# ***City of Albuquerque***

**Re: Checker Auto Store, 10030 Central Ave. SE, Certificate of Occupancy  
(L20/D59)**

**RE: CHECKER AUTO (L20-D59). GRADING AND DRAINAGE PLAN FOR BUILDING AND GRADING PERMIT APPROVALS. ENGINEER'S SEAL DATED June 29, 1998.**

**RE: CHECKER AUTO (L20-D59). GRADING AND DRAINAGE PLAN FOR BUILDING  
AND GRADING PERMIT APPROVALS. ENGINEER'S SEAL NOT DATED.**

DRAINAGE  
SIDEWALK CULVERT  
WITH STEEL PLATE TOP  
DWG. 2236

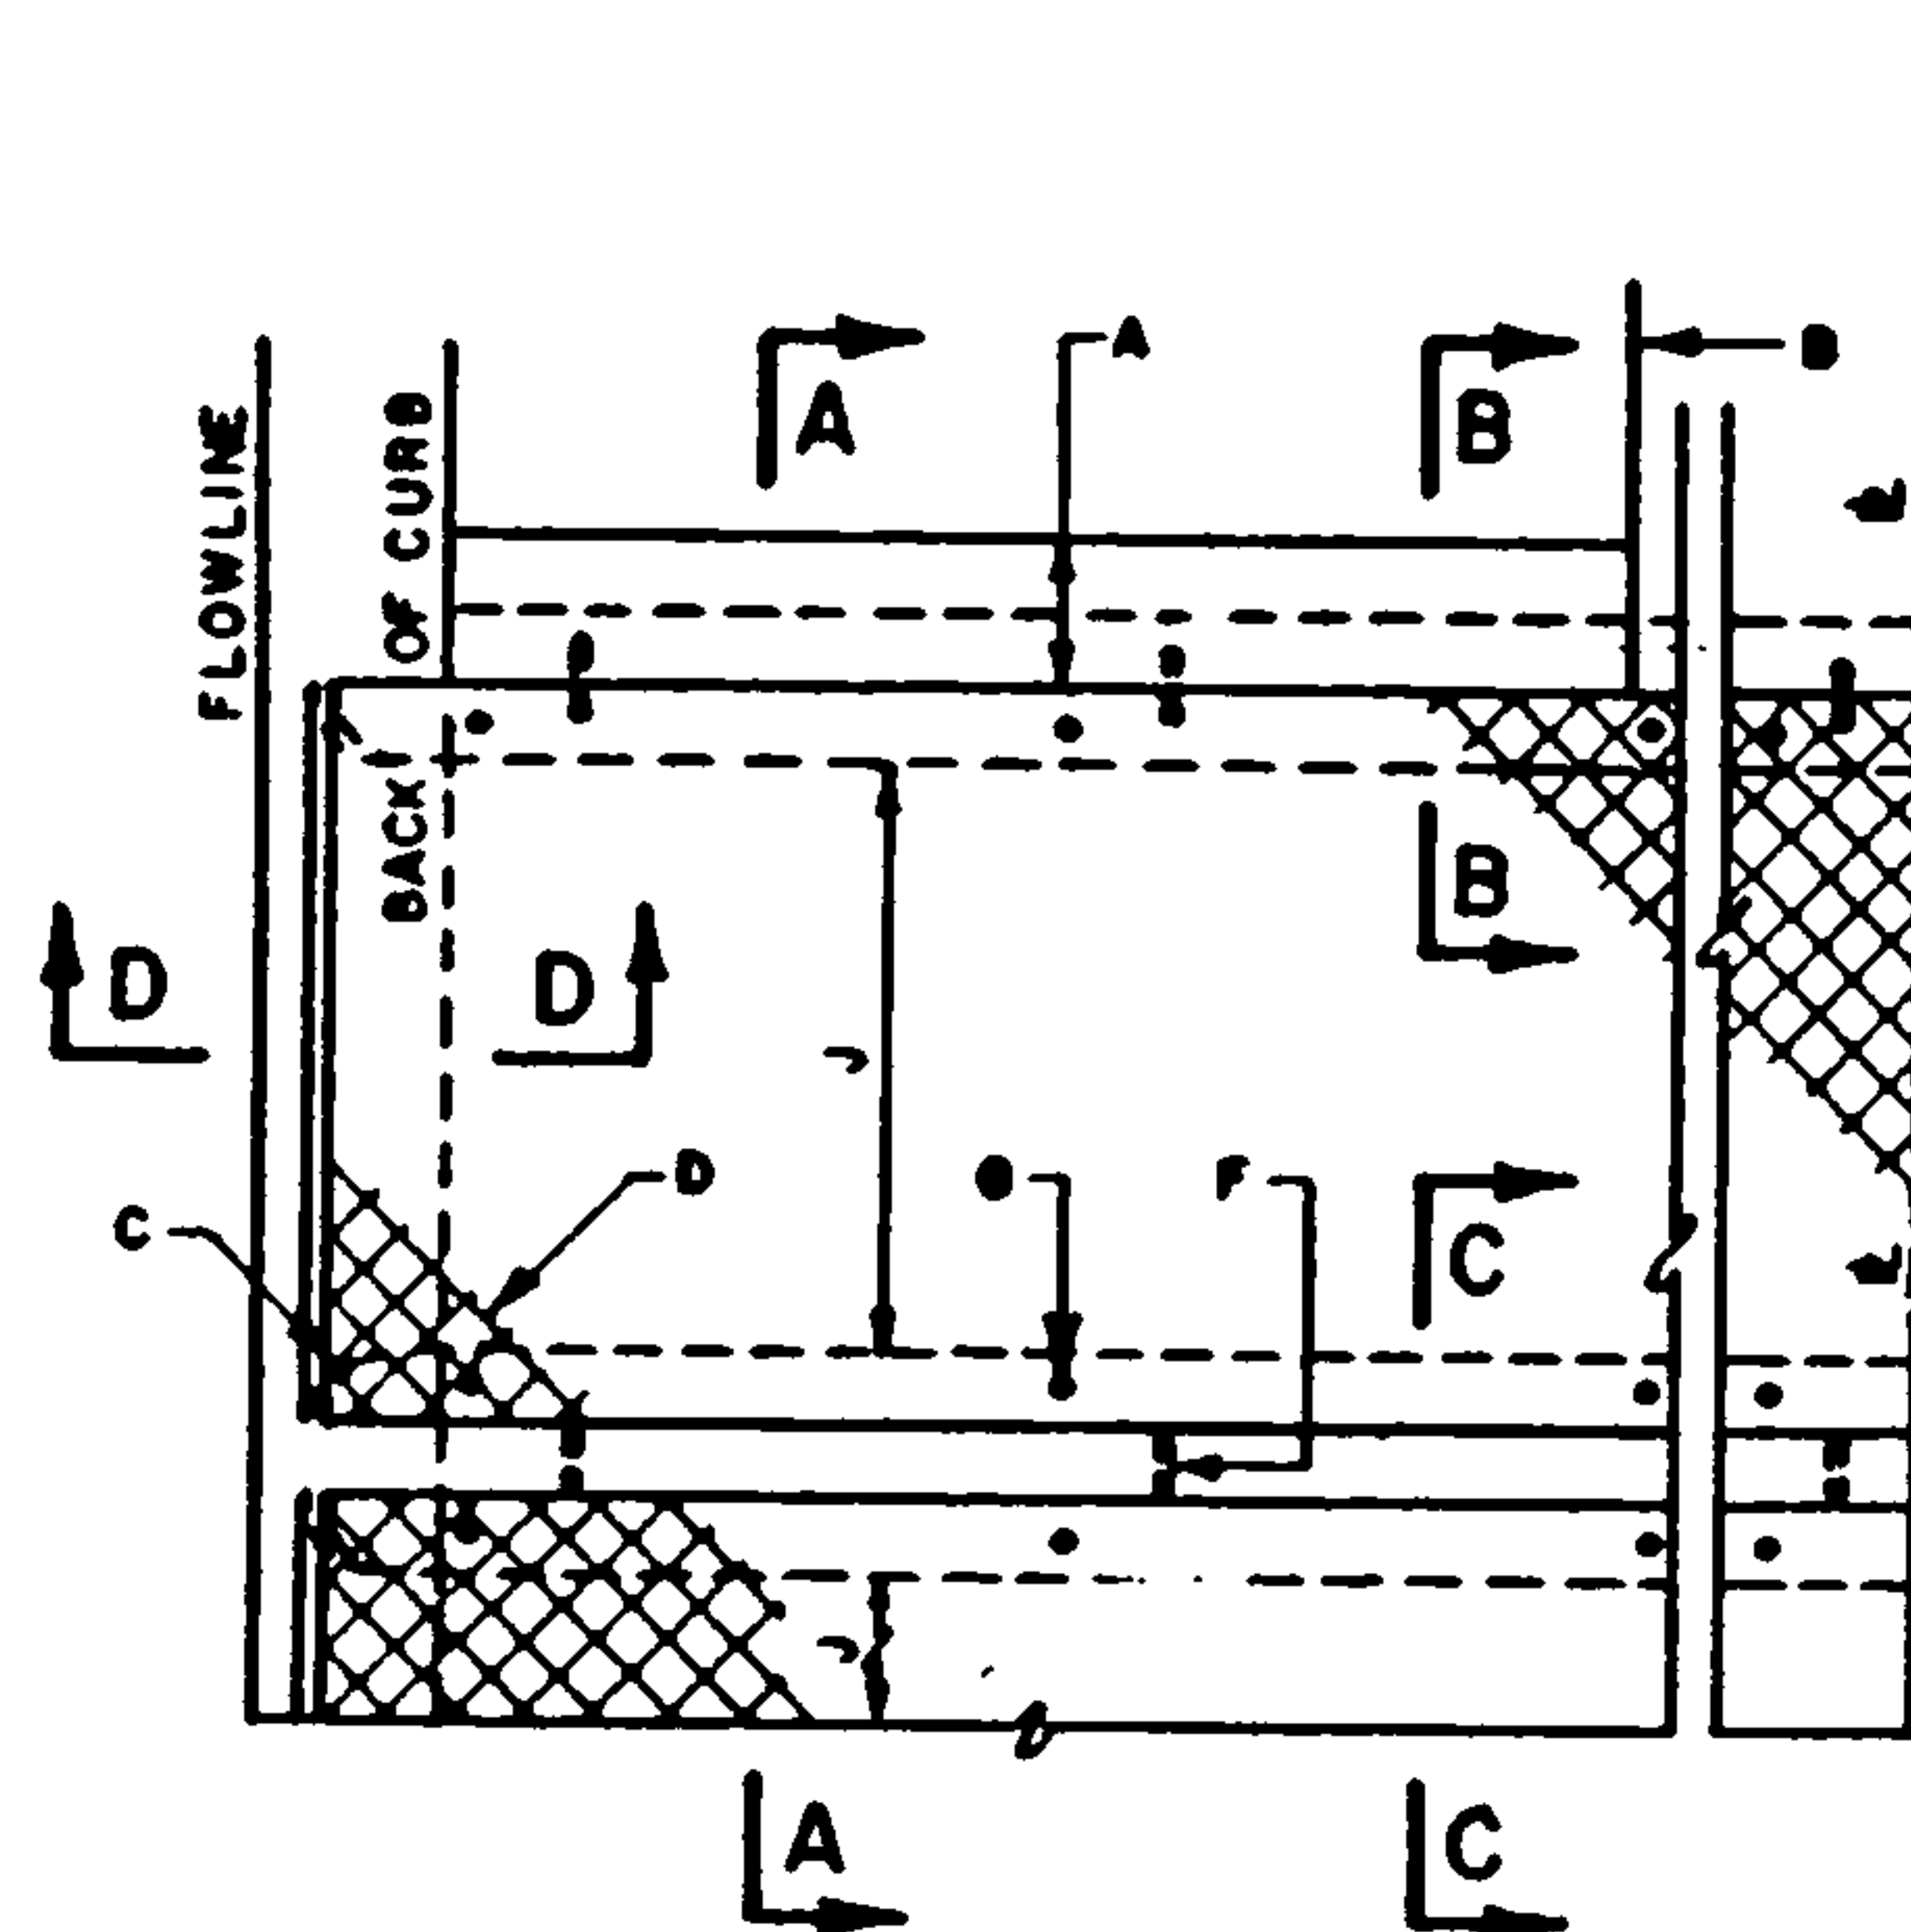
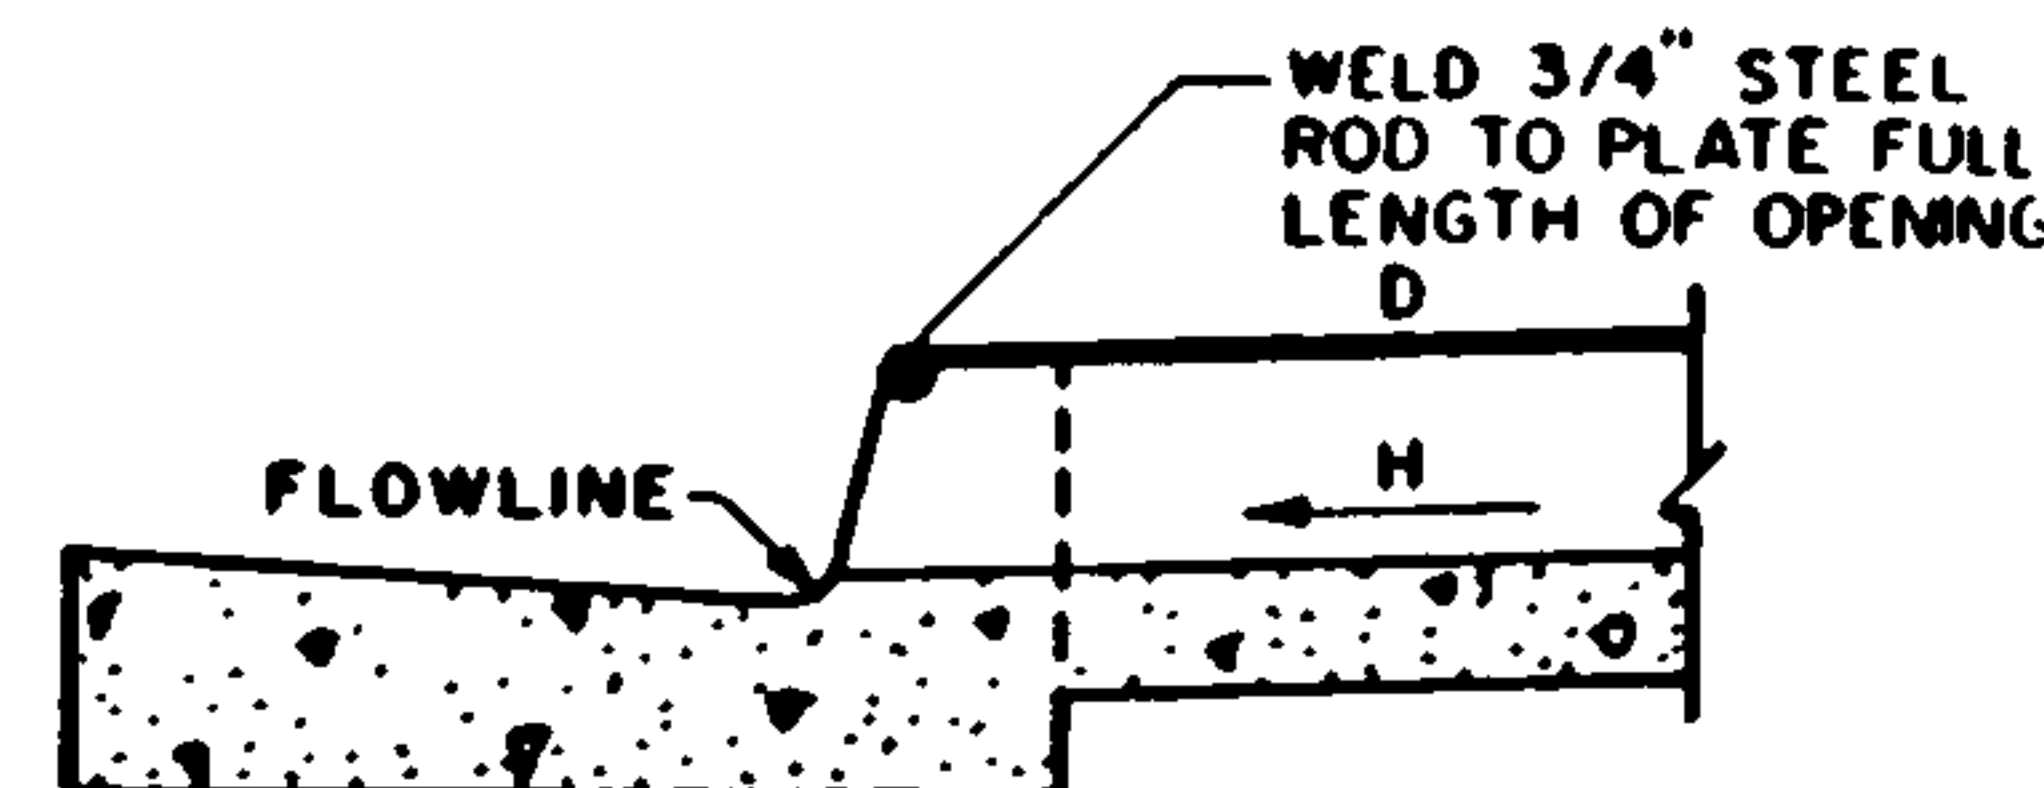
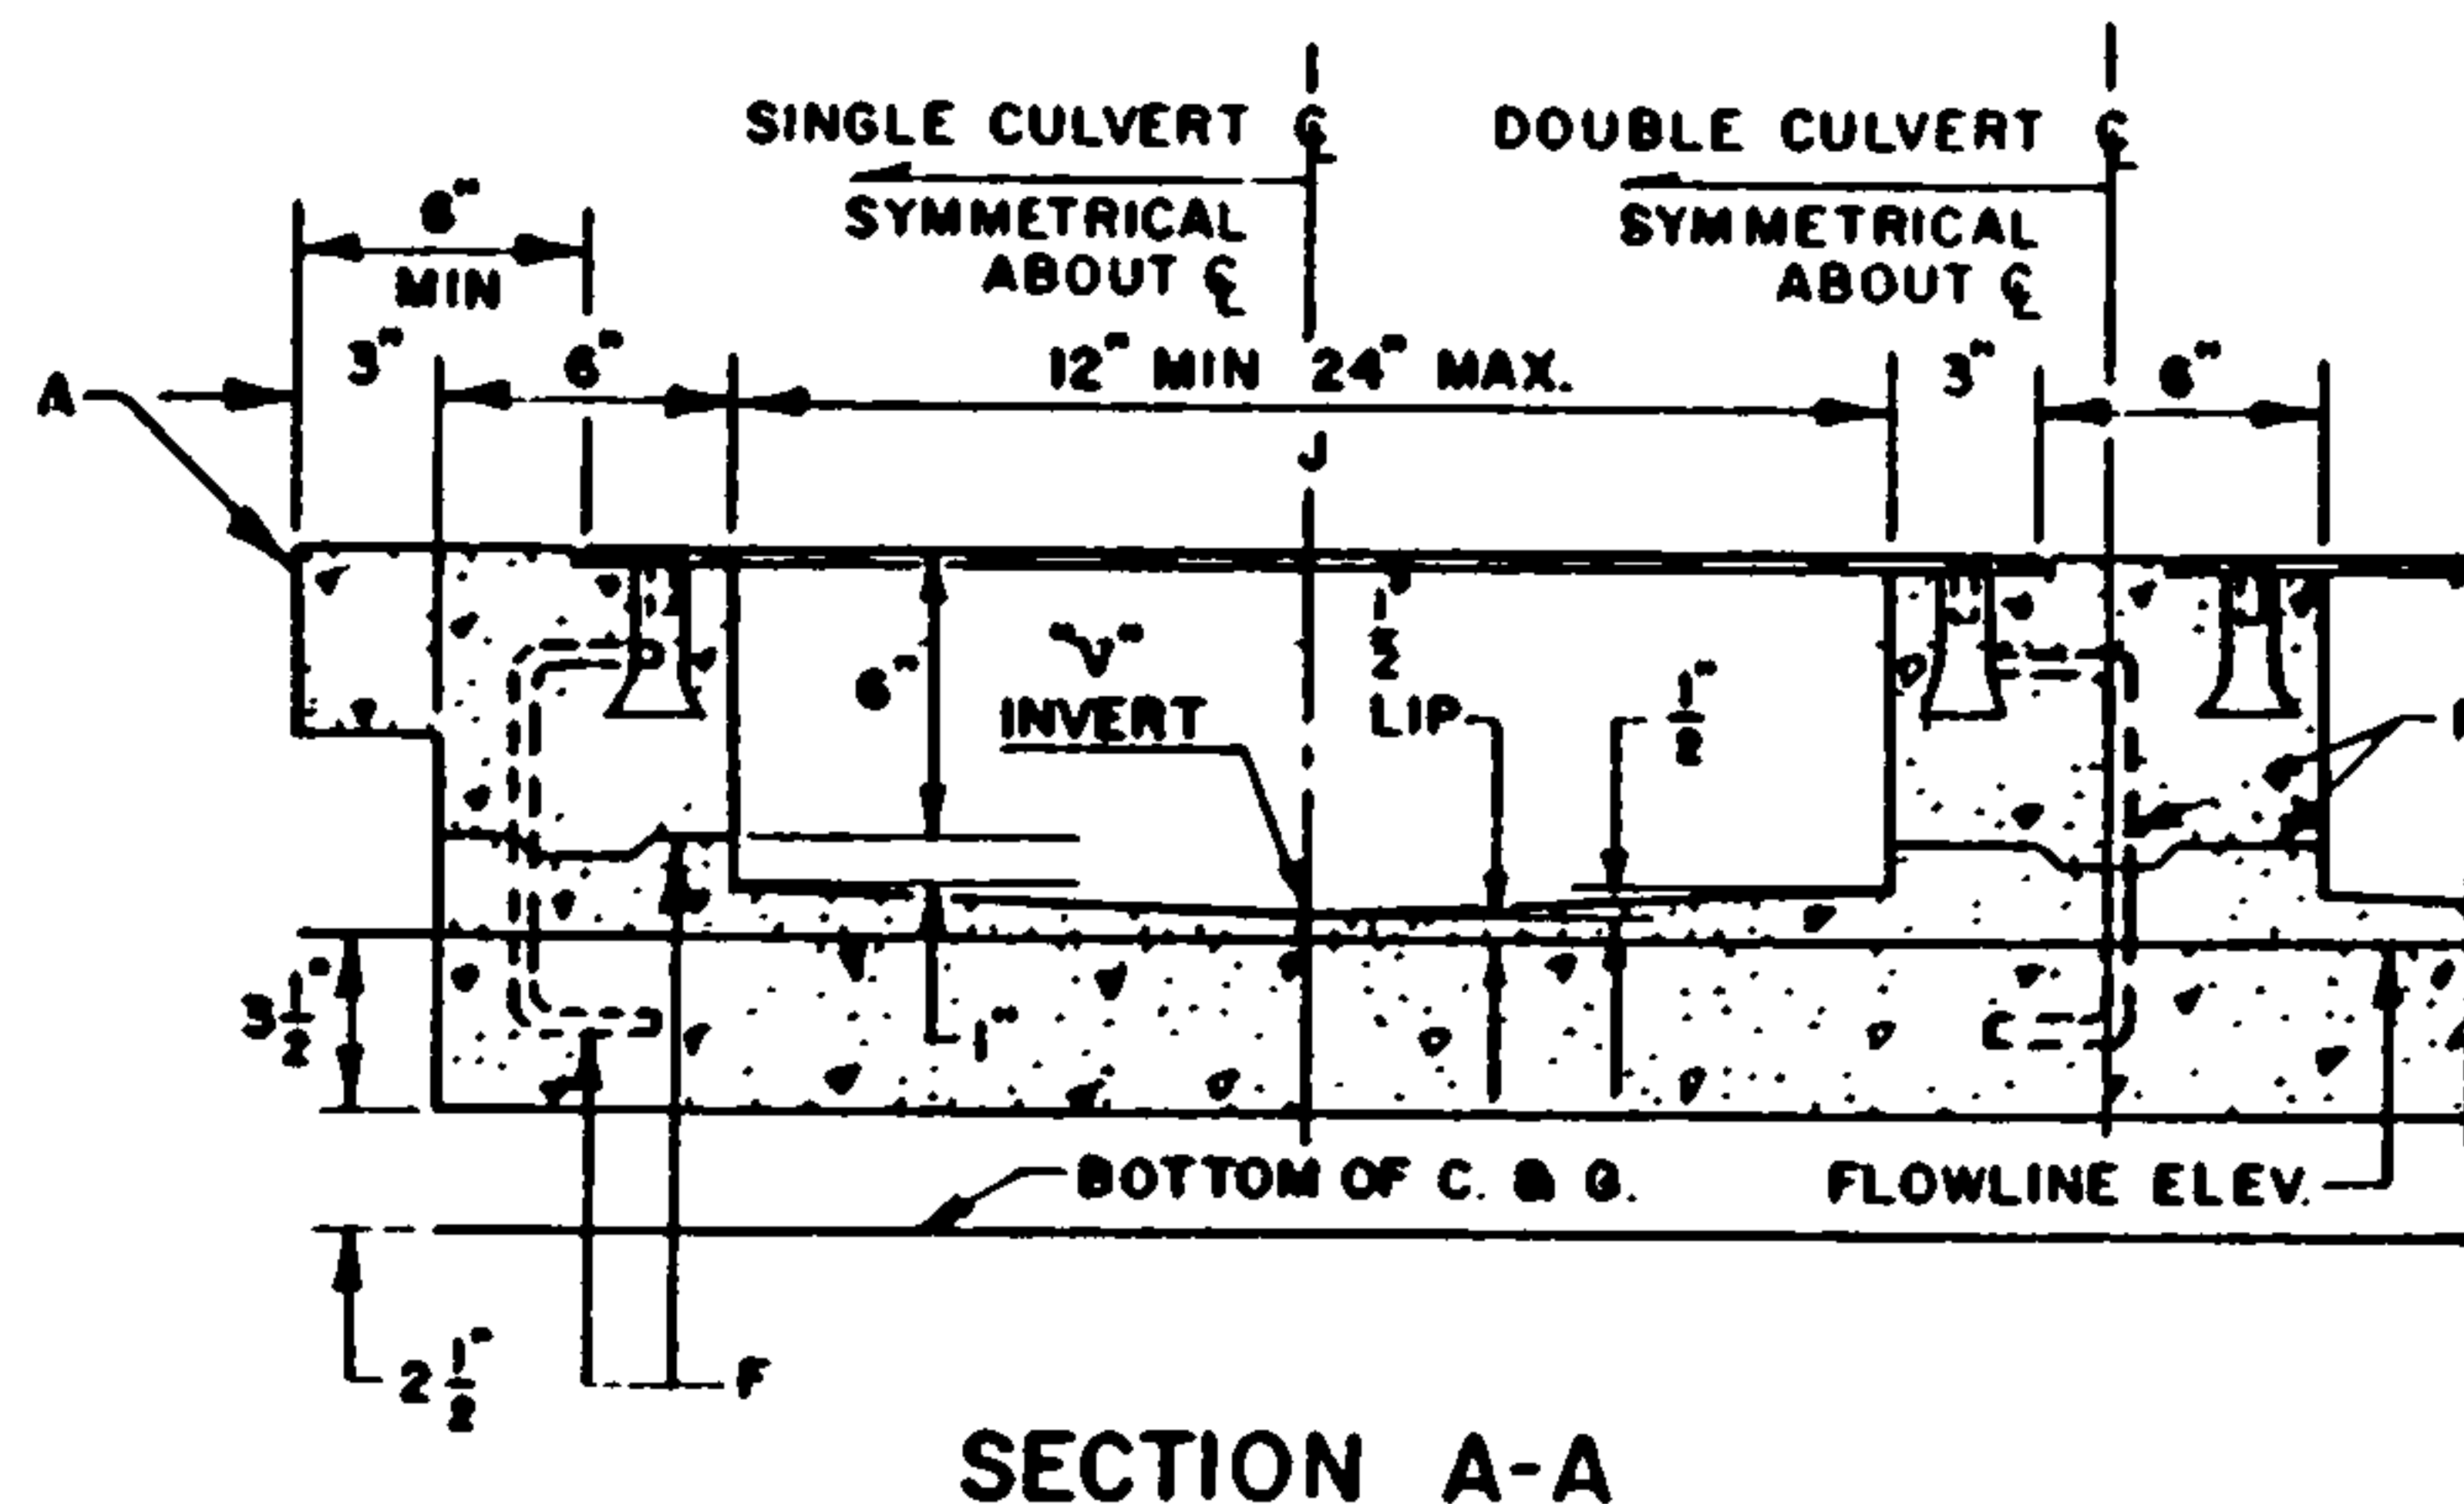
Sidewalk culvert is standard. Refer to City of Albuquerque Standard Drawing 2236 (copy enclosed). Delete detail on Sheet C2. Show calculations for its sizing.
